01 July 2003  
AGE-NC Project No. 99-0556

**Subject: Subsurface Investigation Work Plan - Well Location MW-2  
Former Continental Volvo  
4030 East 14<sup>th</sup> Street, Oakland, California**

SITE PLAN - WELL LOCATIONS  
 FORMER CONTINENTAL VOLVO  
 4030 EAST 14th STREET  
 OAKLAND, CALIFORNIA

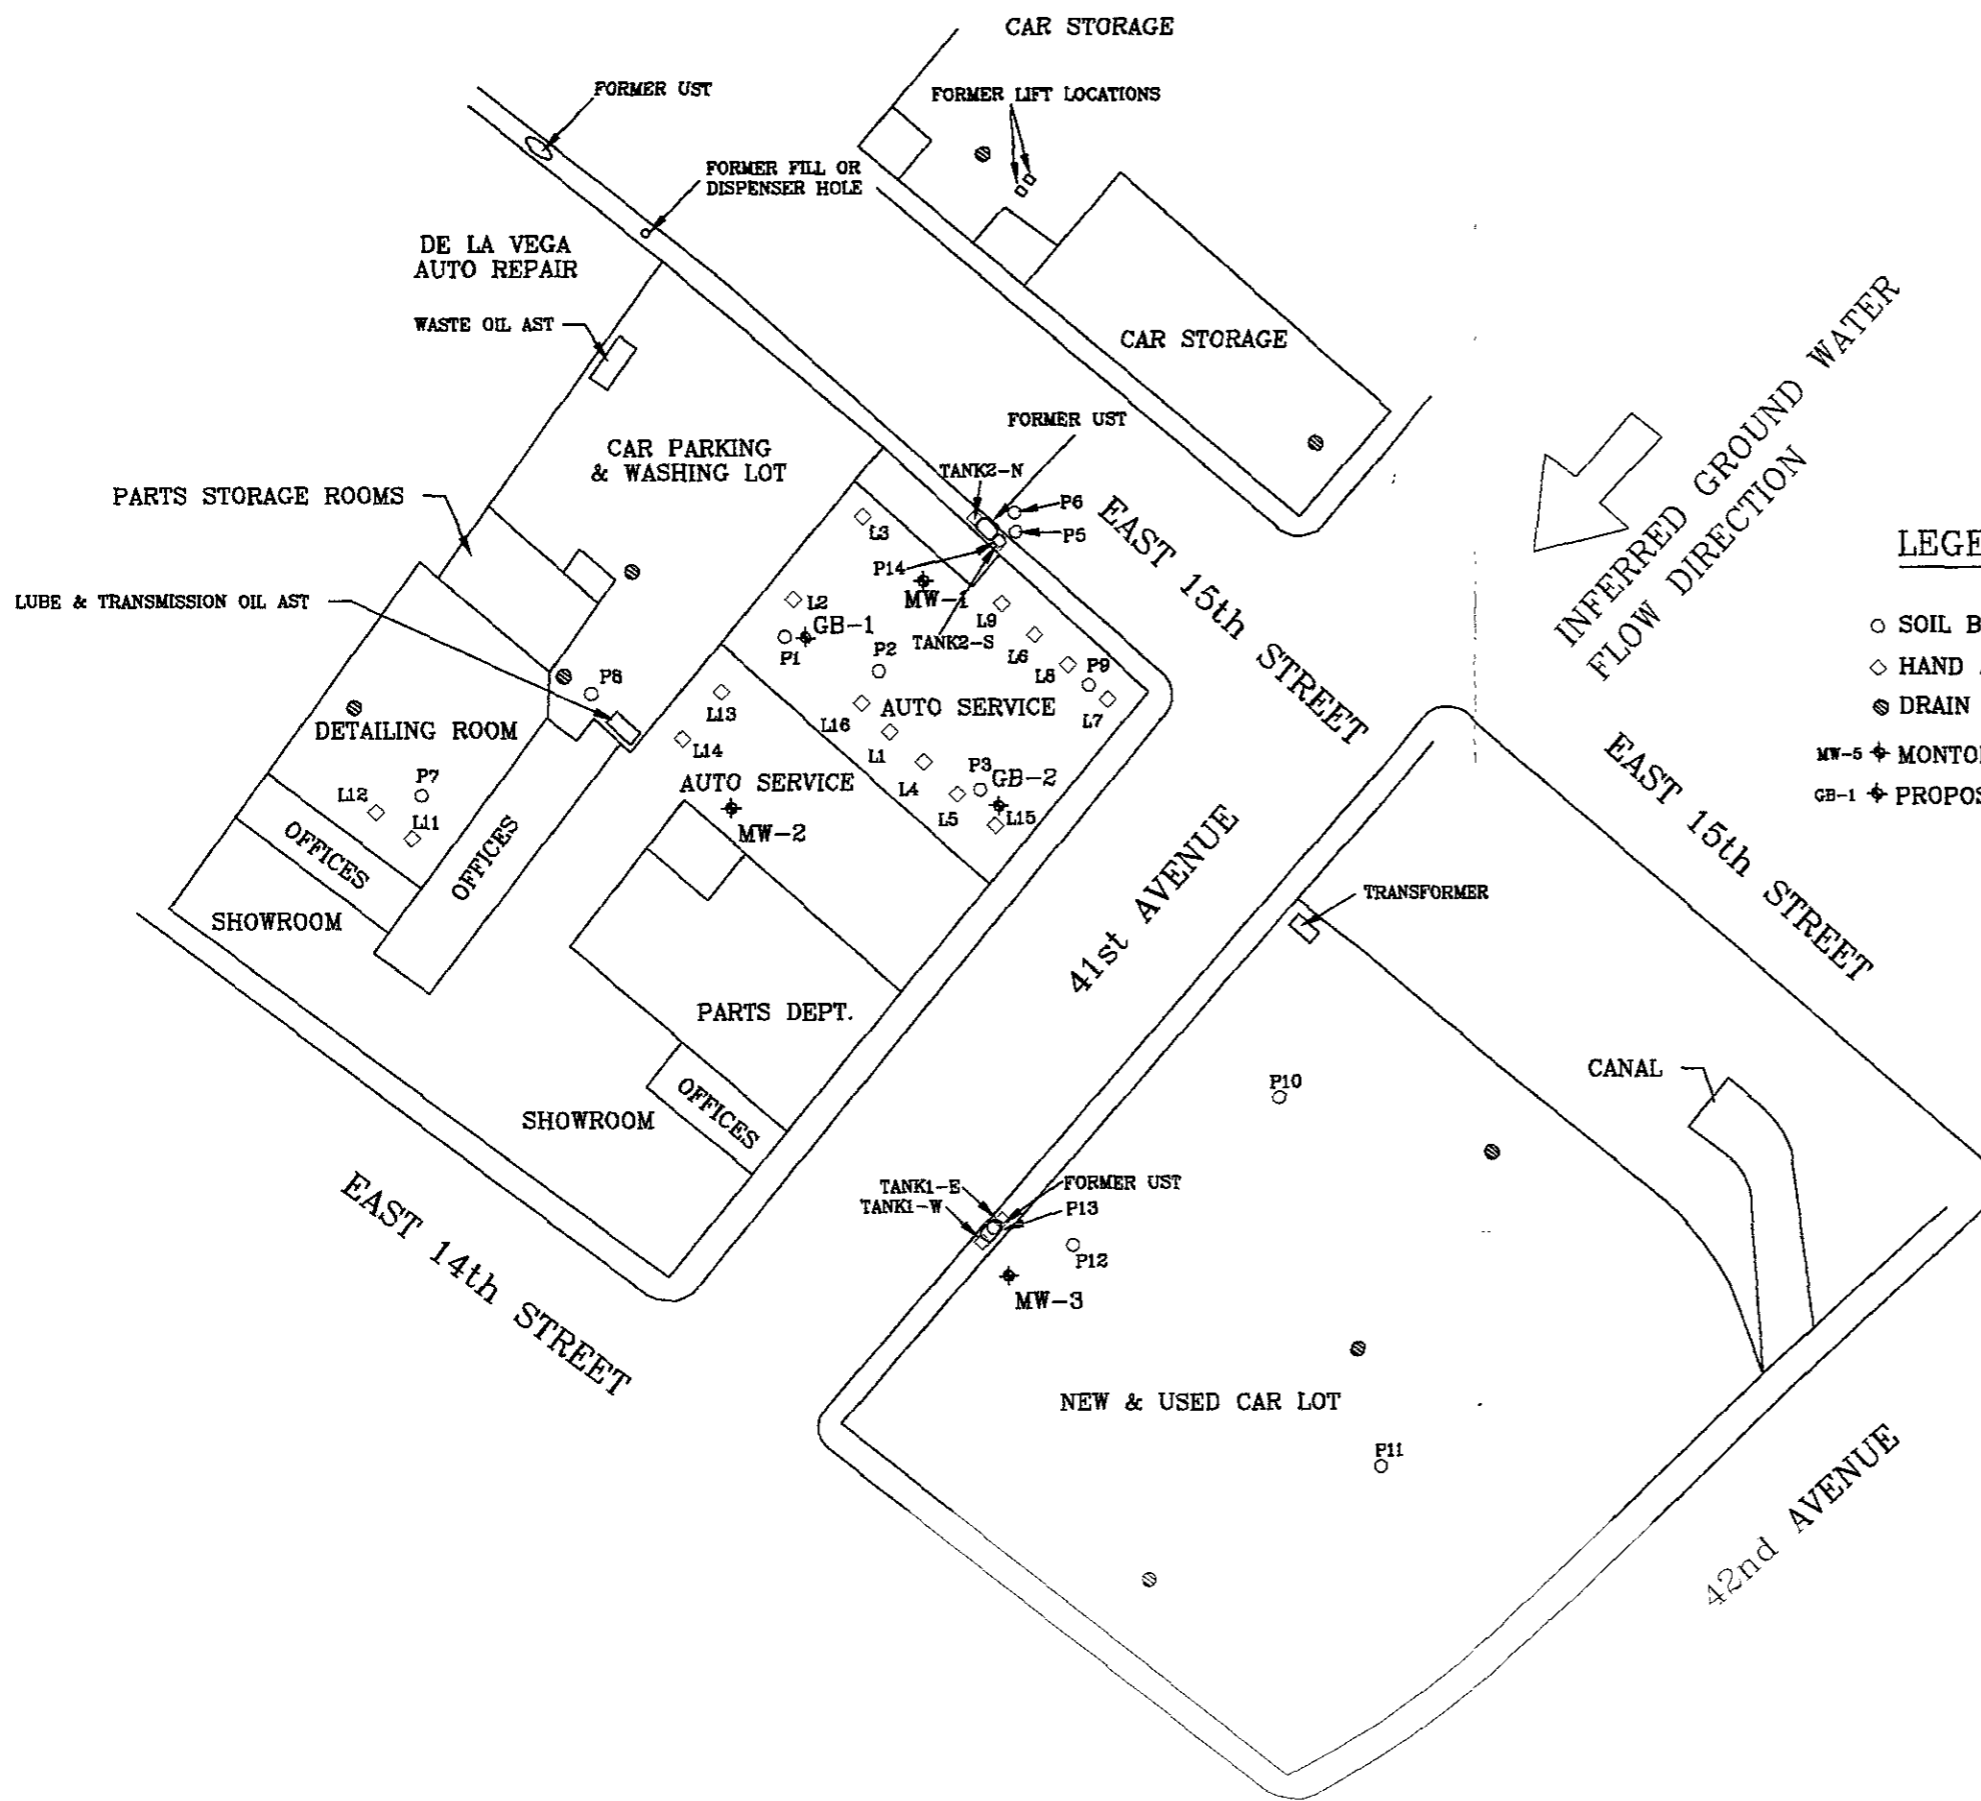
On the 30 June AGE proceeded to advance two Geoprobe soil borings with a macro sampling device, in an attempt to collect ground water. Water was not present in both borings, GB1 down gradient of the former waste oil UST nor in GB2 east of the former waste oil UST, yet towards the former heating oil UST. Both open hole casing and a Geoprobe grab ground water sampler were used to collect any ground water, however, no water was yielded from either soil boring. In order to define the plume of dissolved hydrocarbons, south and southwest of the former waste oil UST, AGE proposes to install the final approved well, designated MW2. This well shall be installed in the service entrance to the dealership. The well will be installed with the same construction as wells MW-1 and MW-3, both which supply adequate ground water for total purges and ground water sample collection. The location of the well is depicted on Figure 2.
